Council Assessment Panel Agenda & Reports

**5.1 DEVELOPMENT NUMBER 24016085 – JUDY BARNETT
 - 16 EDMUND STREET, NORWOOD**

DEVELOPMENT NO.:	24016085
APPLICANT:	Judy Barnett
ADDRESS:	16 EDMUND ST NORWOOD SA 5067
NATURE OF DEVELOPMENT:	Partial demolition at the rear of the existing dwelling and removal of the existing garage, construction of a two-storey dwelling addition and verandah, and relocation and repurposing of the existing verandah to become a garage
ZONING INFORMATION:	<p>Zones:</p> <ul style="list-style-type: none"> • Established Neighbourhood <p>Overlays:</p> <ul style="list-style-type: none"> • Airport Building Heights (Regulated) • Historic Area • Prescribed Wells Area • Regulated and Significant Tree • Stormwater Management • Traffic Generating Development • Urban Tree Canopy <p>Technical Numeric Variations (TNVs):</p> <ul style="list-style-type: none"> • Minimum Site Area (Minimum site area is 200 sqm) • Maximum Building Height (Levels) (Maximum building height is 2 levels)
LODGEMENT DATE:	7 Jun 2024

Project	16 Edmund St Norwood
Drawing	Proposed Side Elevations
Date	10 Sept 2024
Scale	1:100
Drawing No.	DA-006
Contact

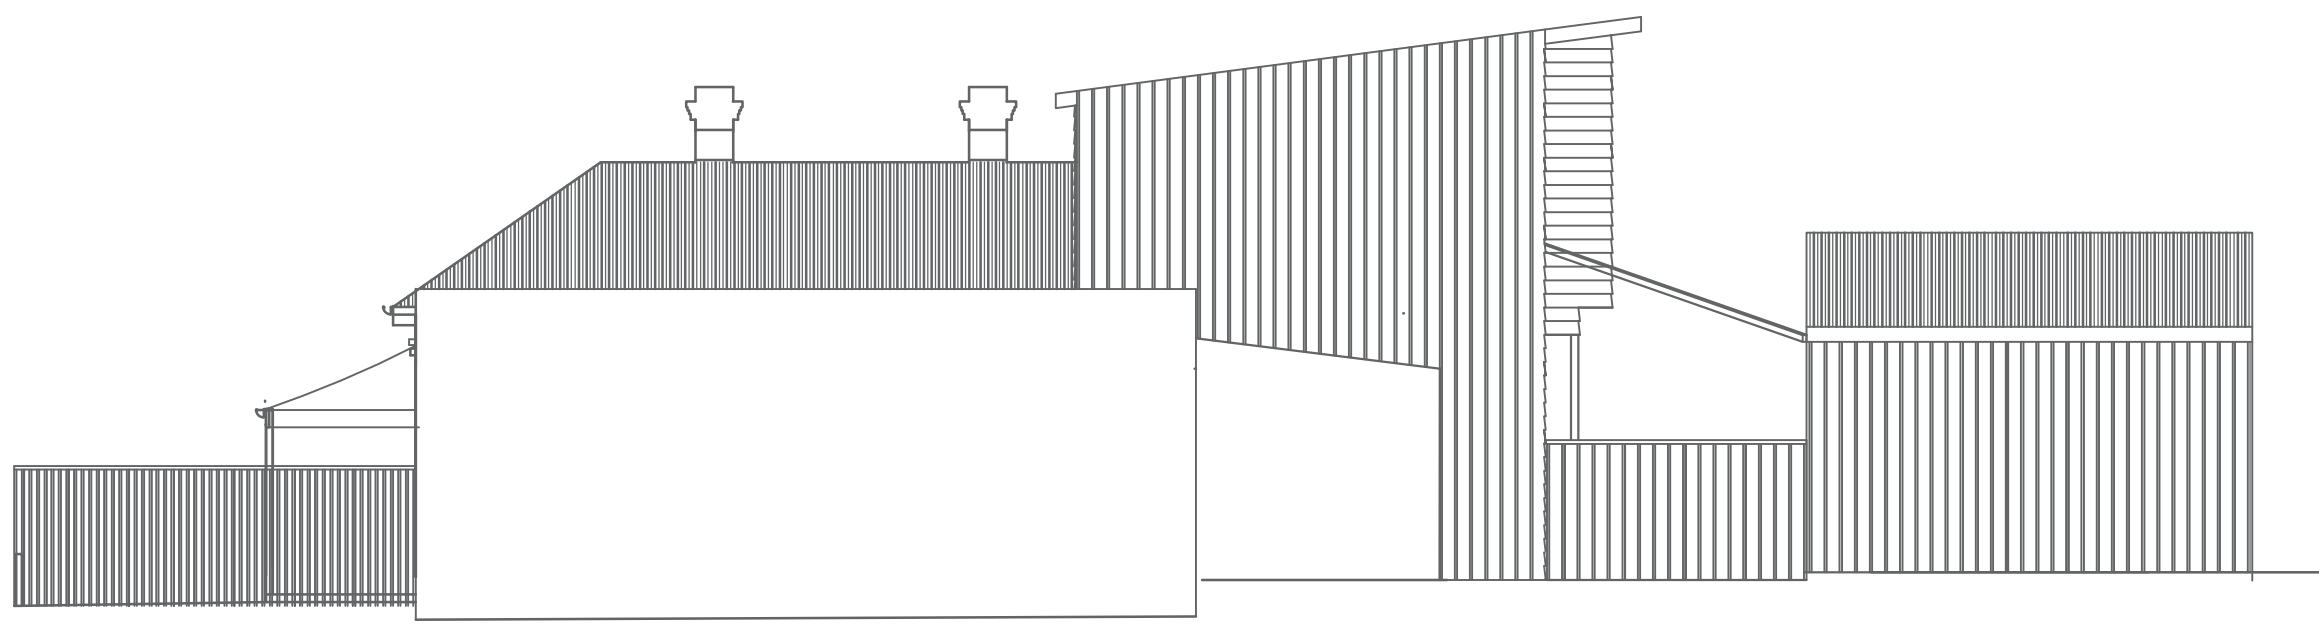
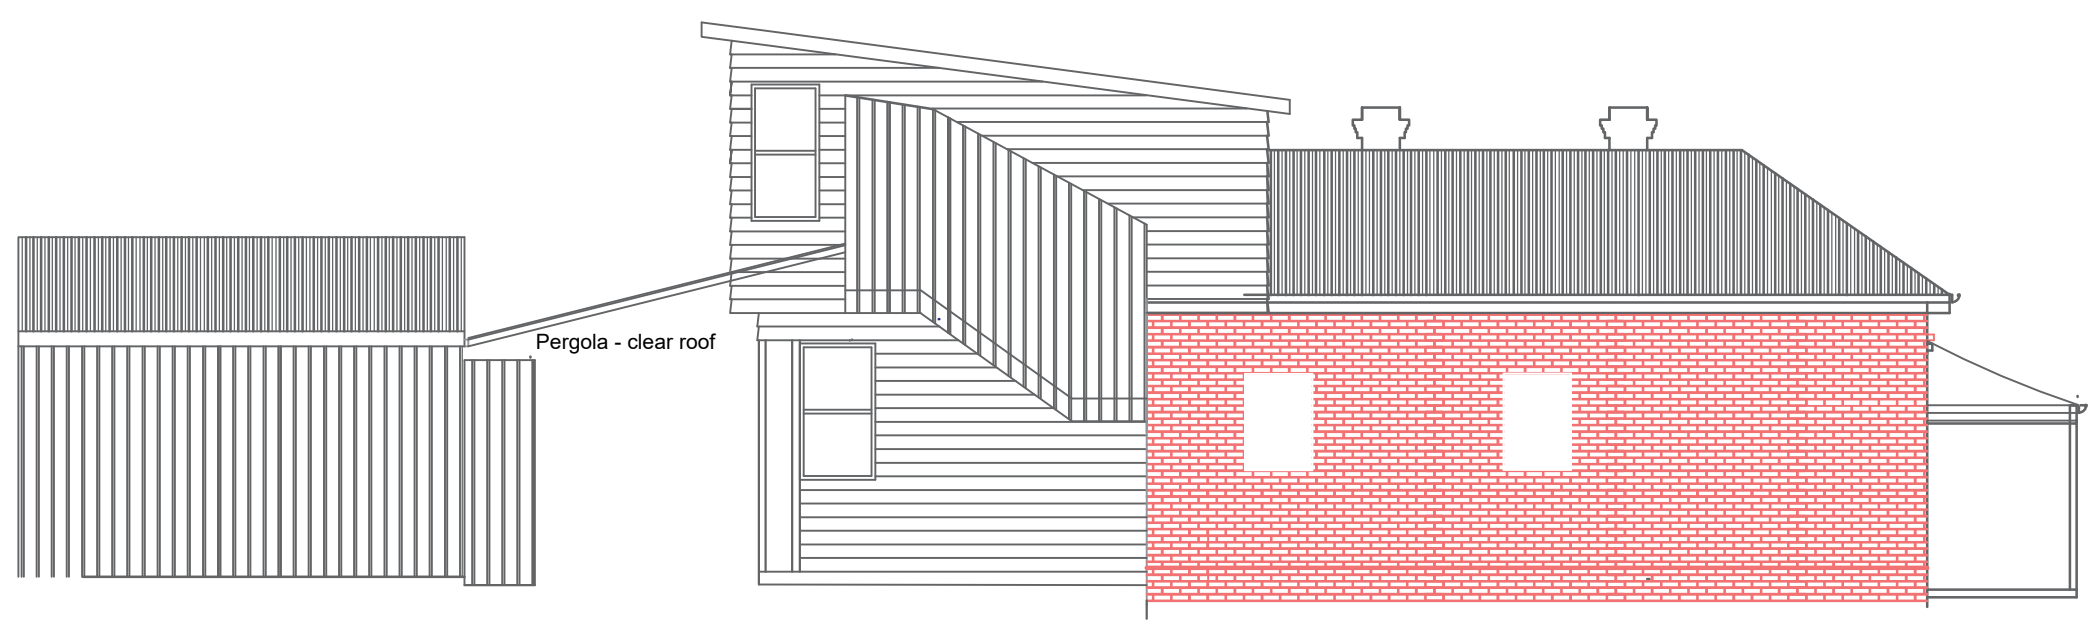
With regard to visual impact to the south (the direction of all representors), the proposed addition largely replaces an existing, single-storey boundary wall, though it would be 1.5m longer. This would about the neighbouring verandah area. The only view of the upper level from the south would be looking from the rear of the properties (the garages) back towards the houses (i.e. standing on the eastern side of the allotment and looking north and west). This tends to be a secondary view, while people are generally looking out from the rear of their dwelling, where the proposed development will be largely imperceptible compared to the existing single storey wall.

Project	16 Edmund St Norwood
Drawing	Proposed Plumbing and roof
Date	10 Sept 2024
Scale	1:100
Drawing No.	DA-015
Contact

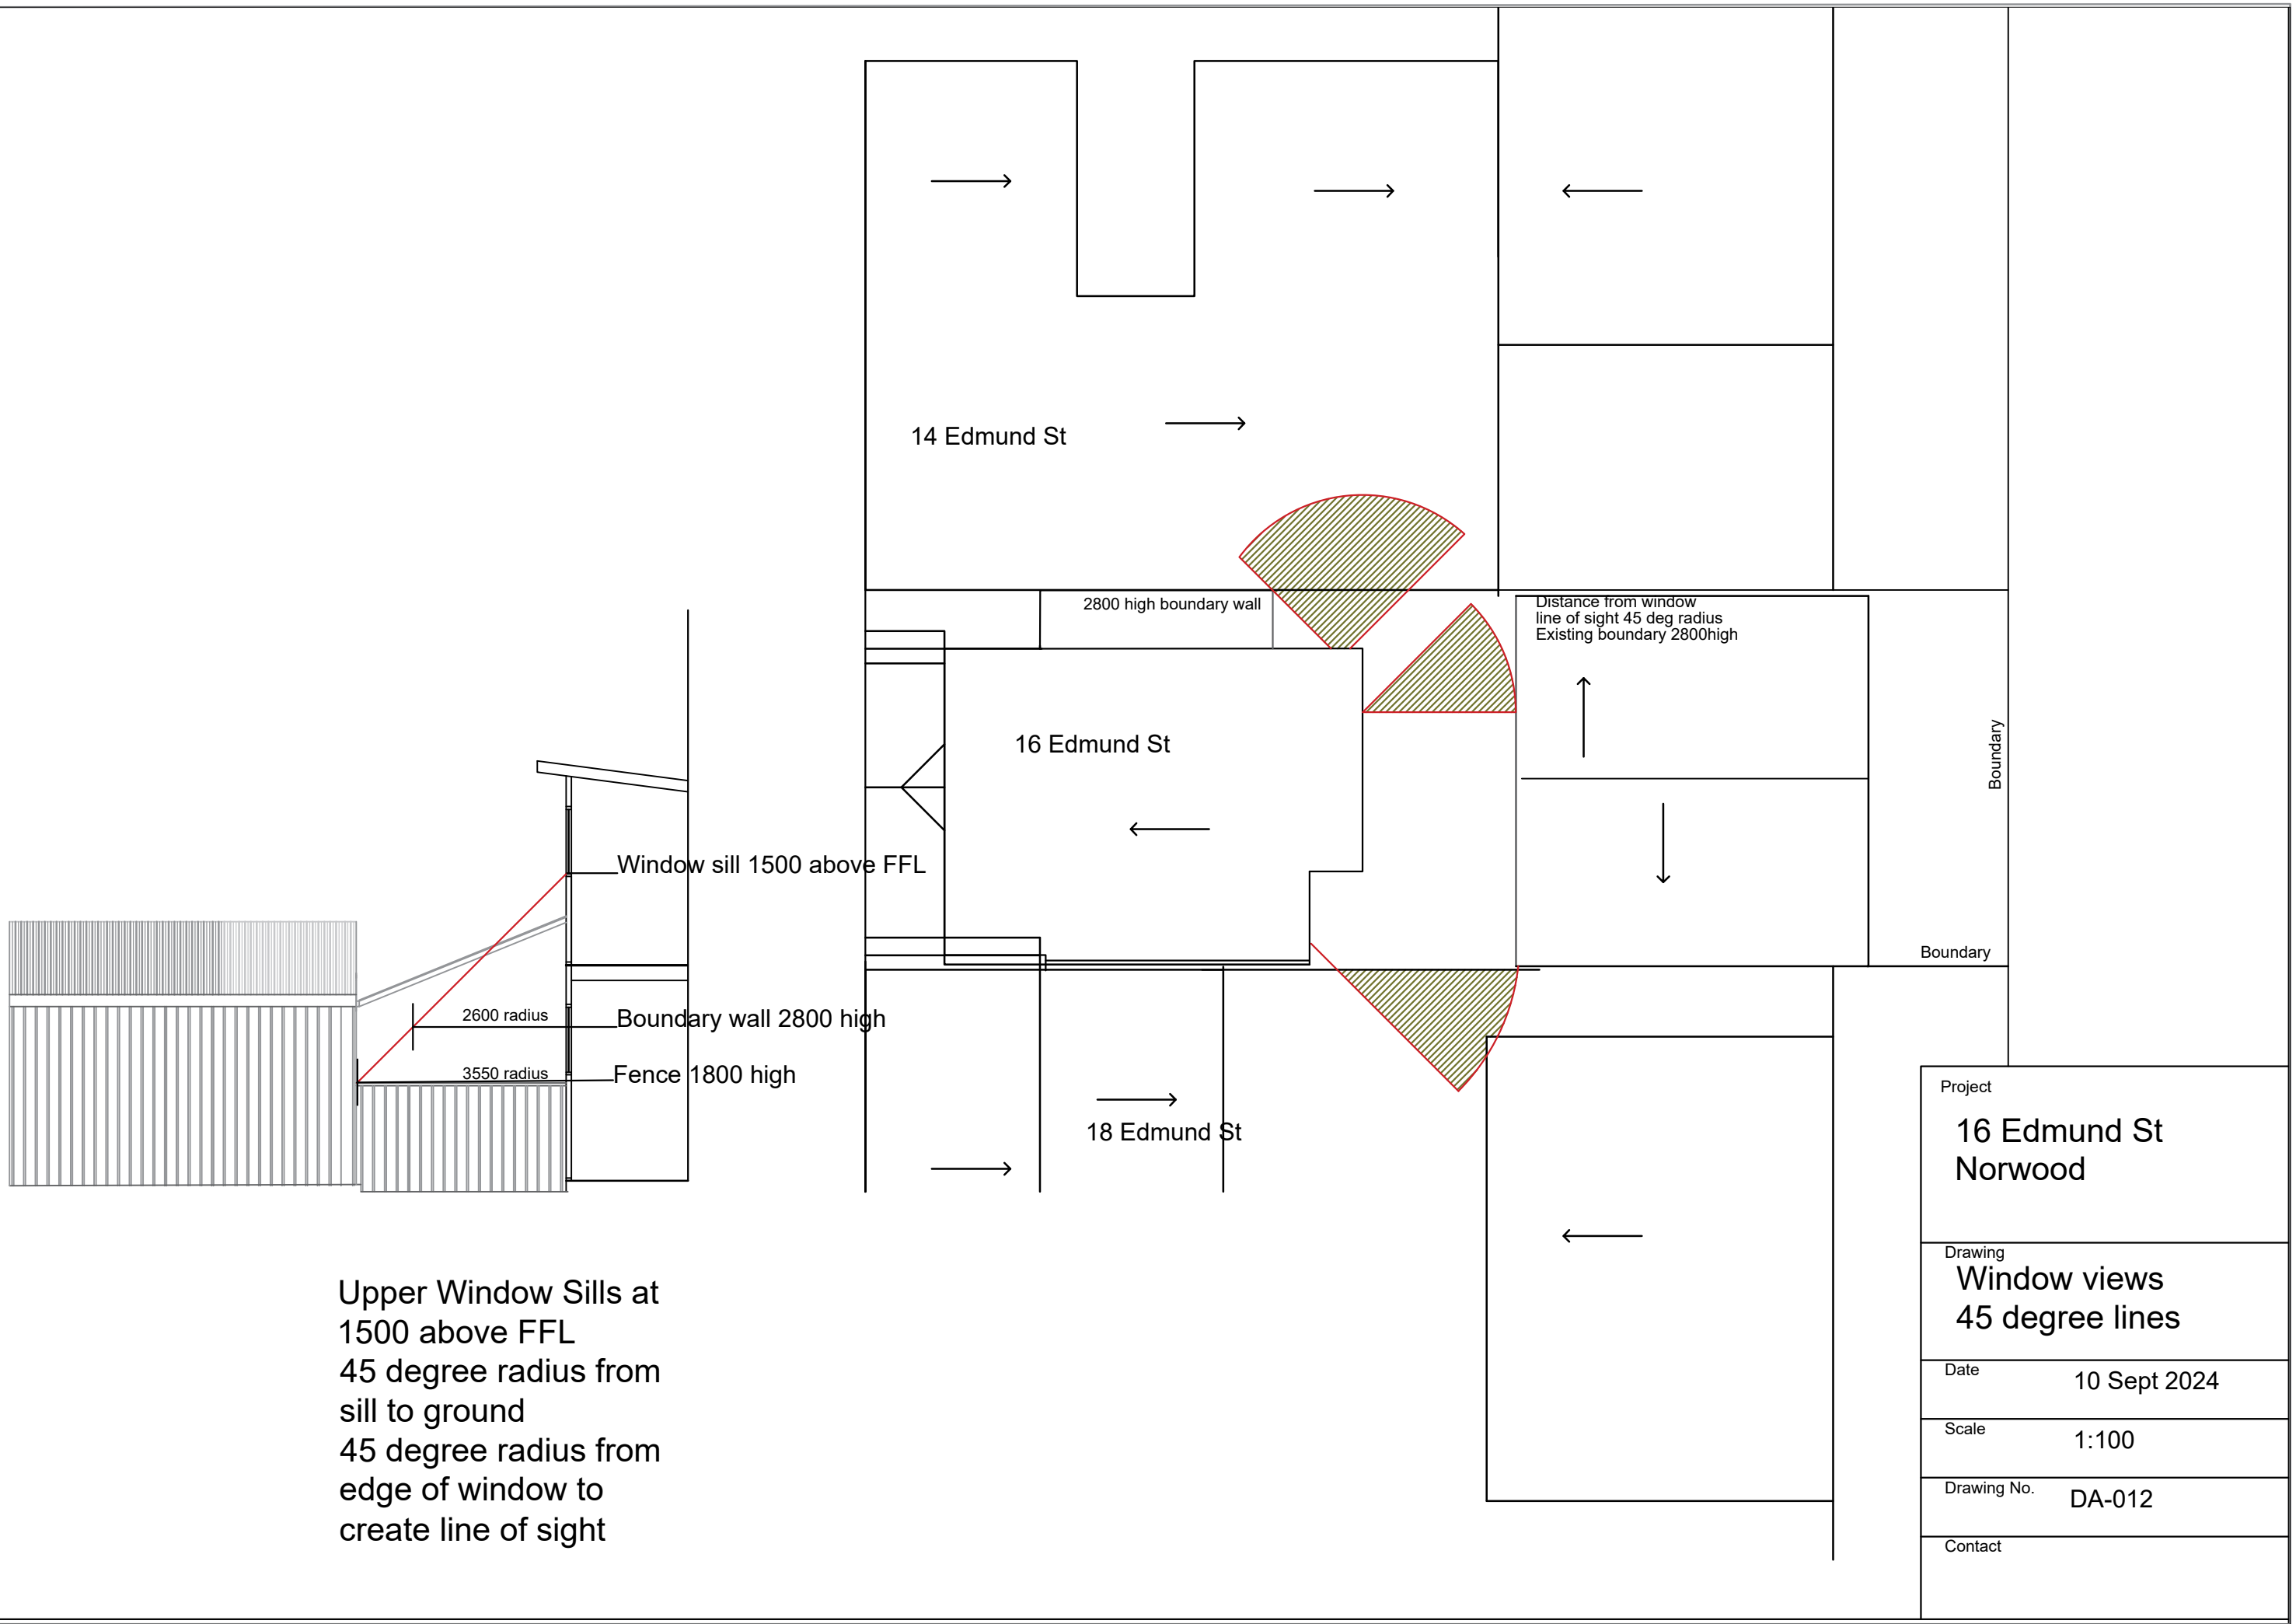
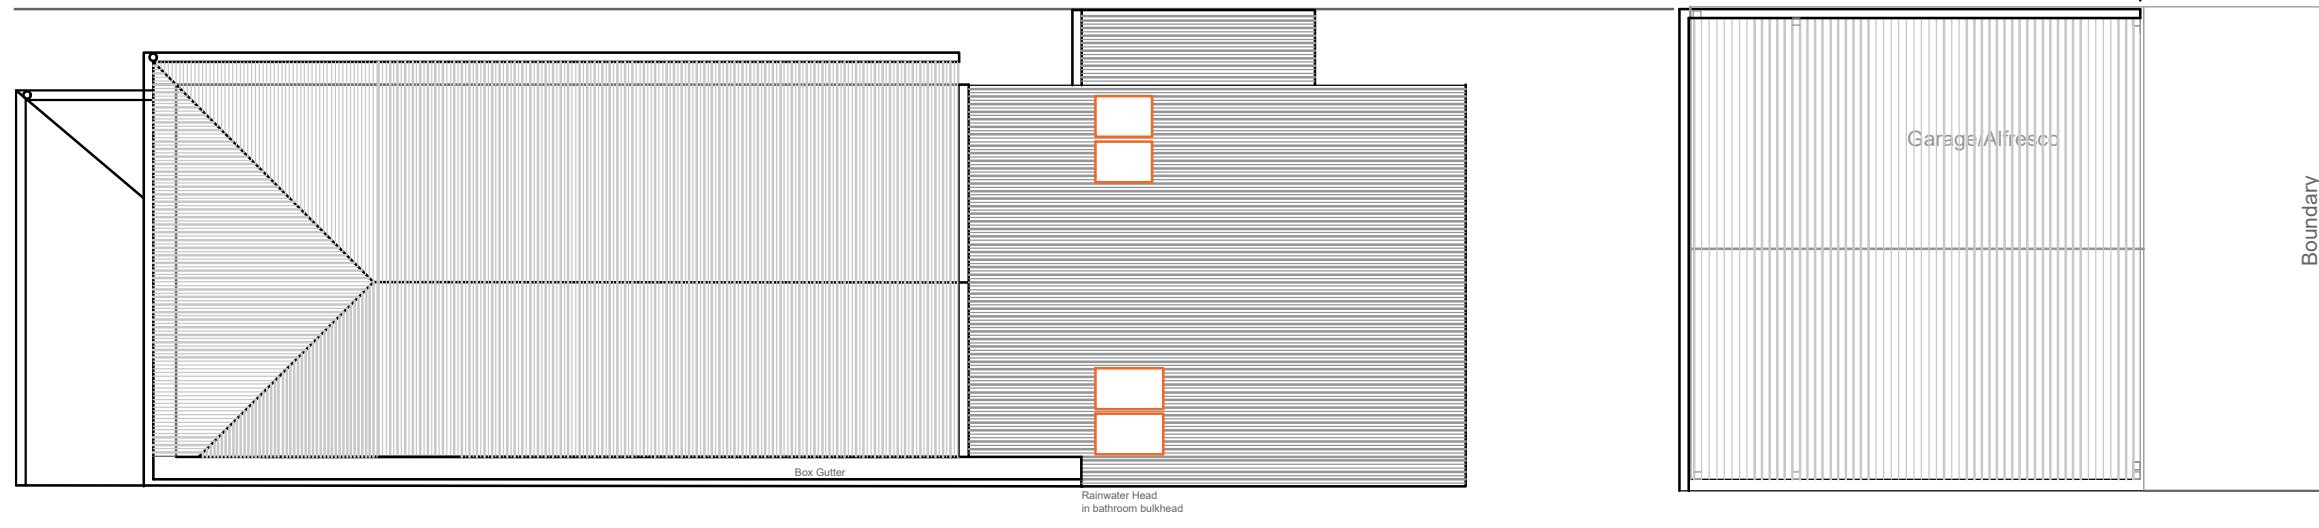
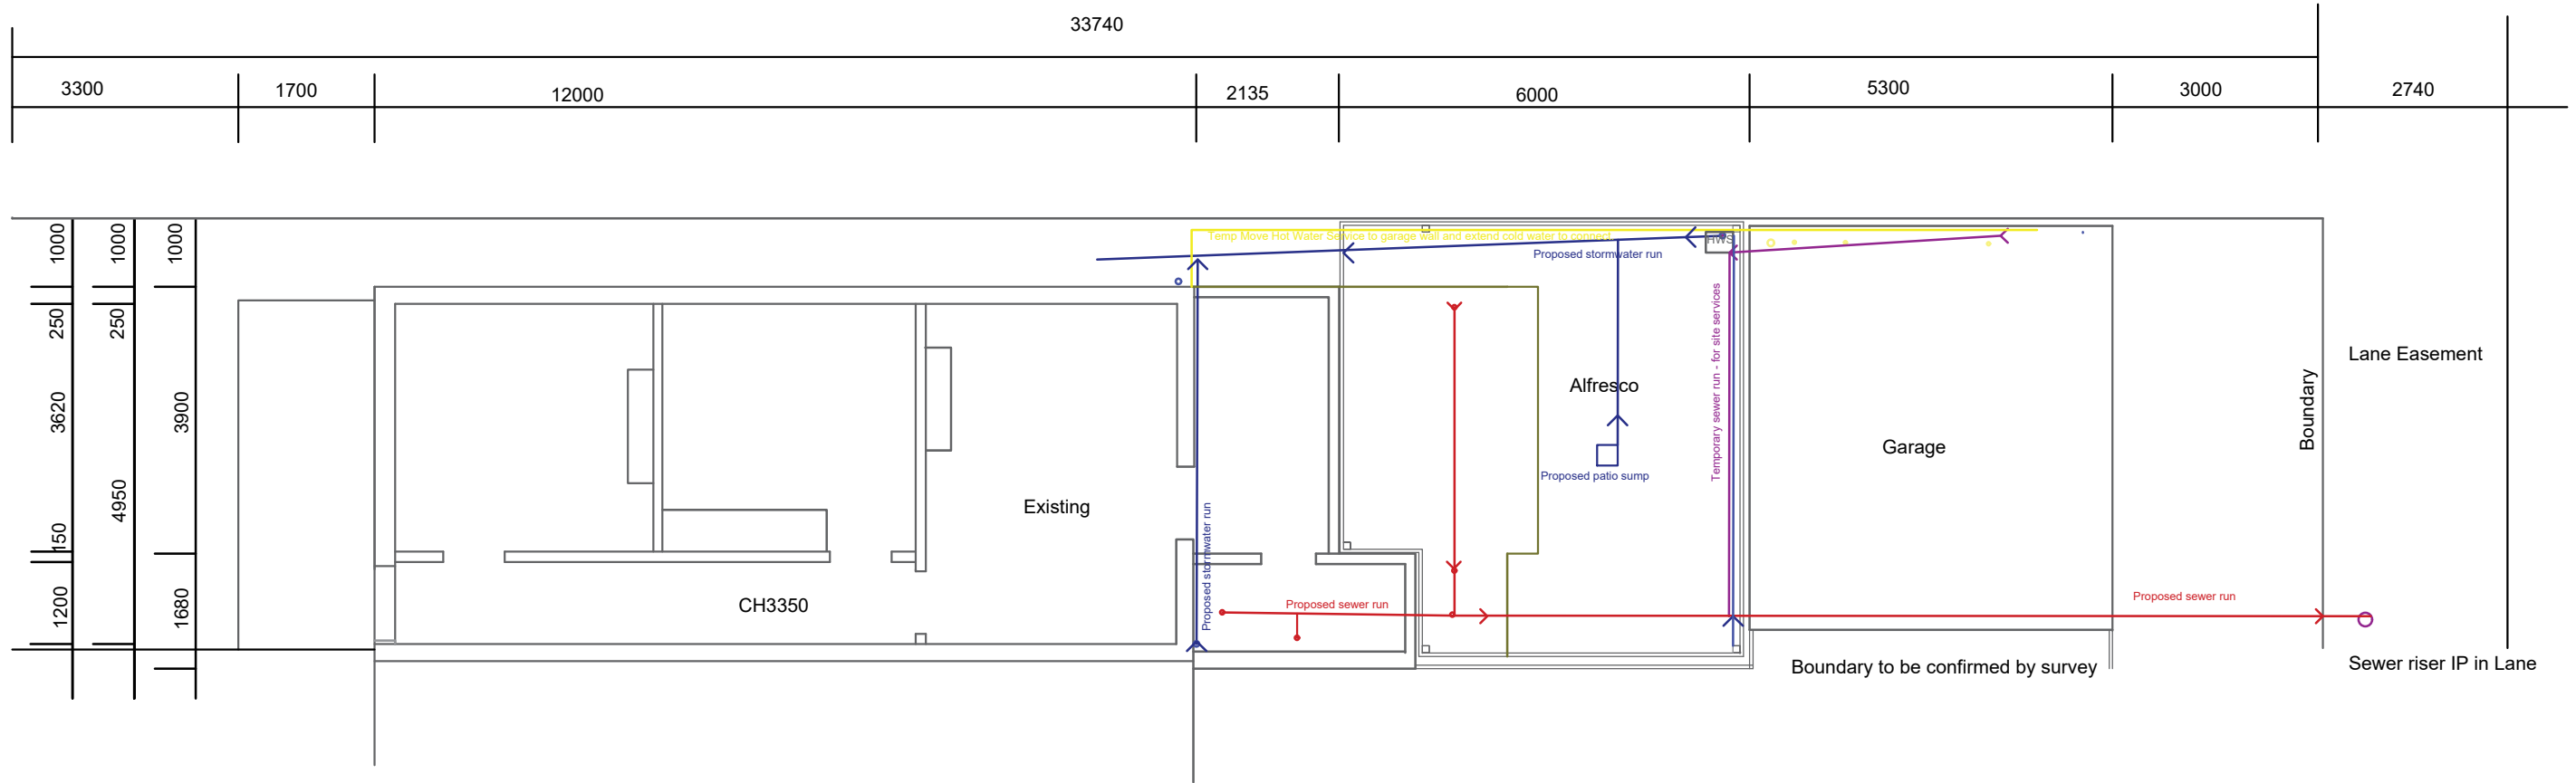
The applicant has clarified that the windows will have sill heights of 1.5m above the upper floor FFL, which will comply with Design in Urban Areas DPF 10.1, which is the relevant guideline in the Code.
